1975 - 1982 Corvette: Service Bulletin: Viton Accelerator Pumps - Current and Past Models Equipped with Dual and Quadrajets

Source: Chevrolet Dealer Service Information Bulletin

Bulletin No: 83-I-65

Date: May, 1983

FIGURE 1. (DUALJET SHOWN)

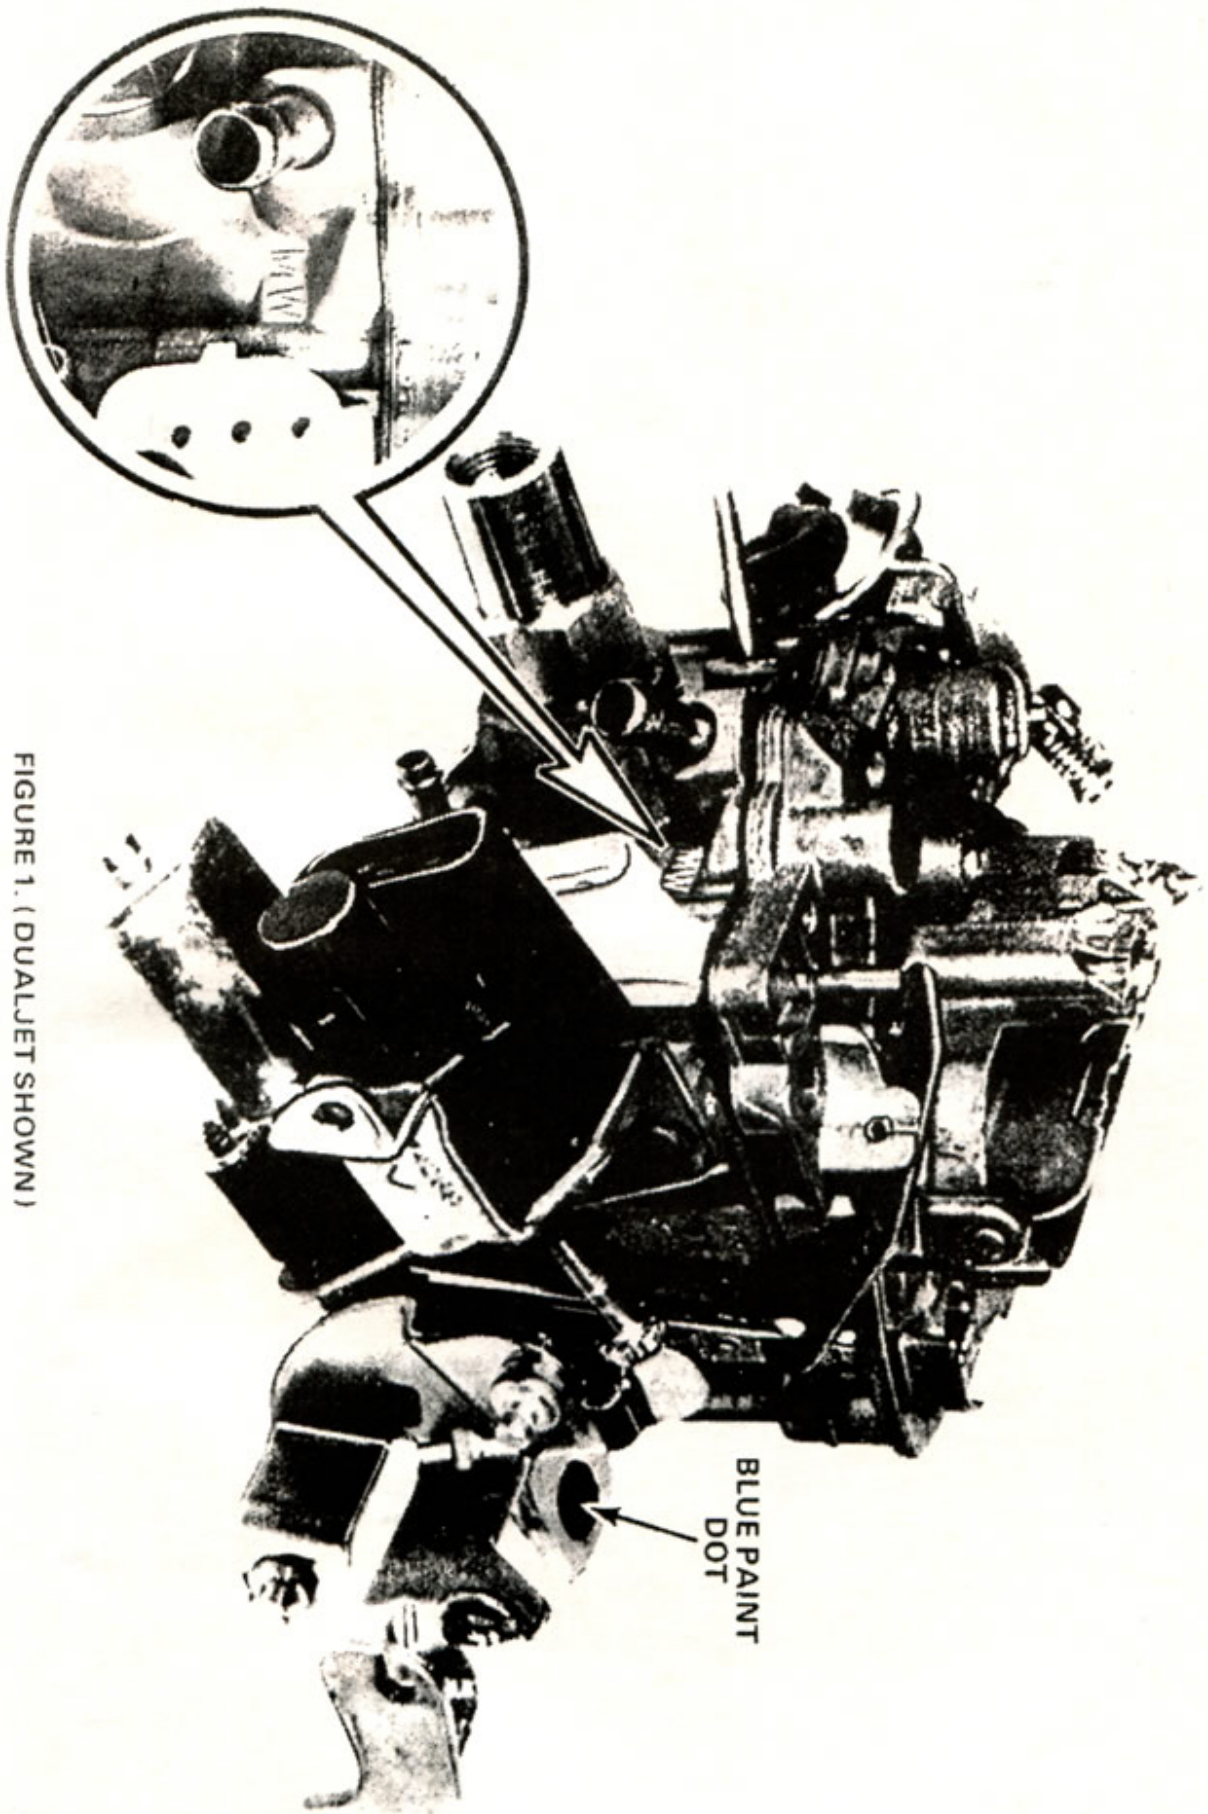
Float bowl assemblies that have the letters "MW" (machined well) embossed next to the throttle position sensor electrical connector use the red lip (with garter spring) viton accelerator pump only . See Figure 1.

Some 1982-83 "MW" flat bowl assemblies used during production were assembled with the red viton pump and some were not. if the float bowl

assembly does not contain the red viton pump, a blue dot will be on the rear of the throttle body near the bolt hole. See Figure 1.

BLUE PAINT
DOT

If the letters "MW" are not on the float bowl assembly, a blue, thin lip accelerator pump can be used per the part list included with this bulletin. This float bowl assembly has the non-machined pump well and uses the blue, thin lip accelerator pump only .

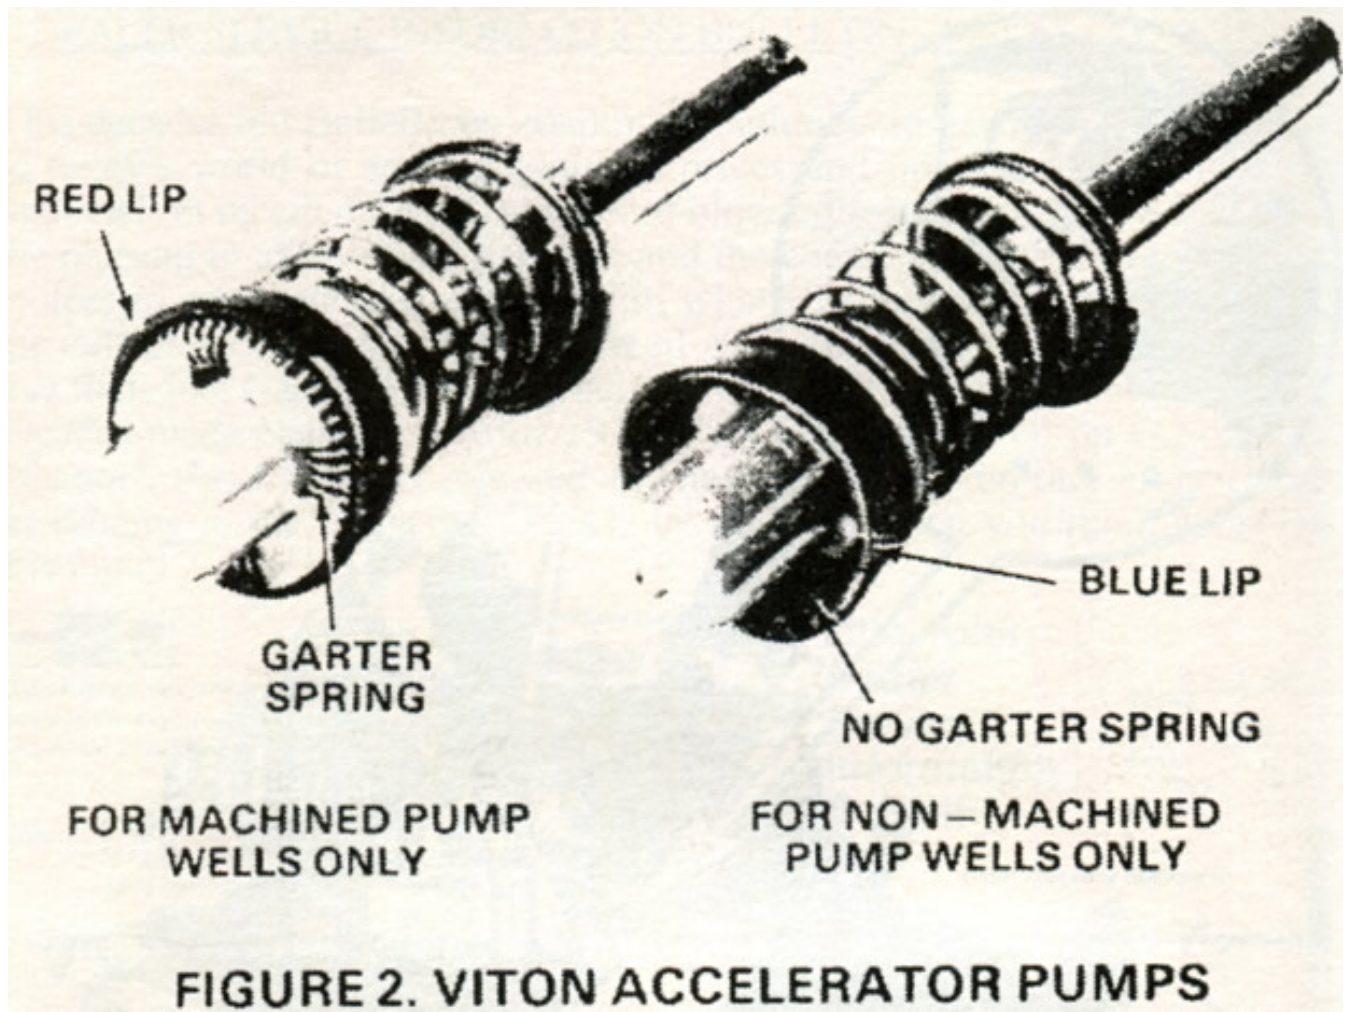
Viton service replacement pumps are identified as H.D. (Heavy Duty) in the parts book and are shown in Figure 2.

Red lip (with garter spring) -- Machined well only (MW)

Blue, thin lip -- Non-machined well only

Red lip (with garter spring) -- 17072978
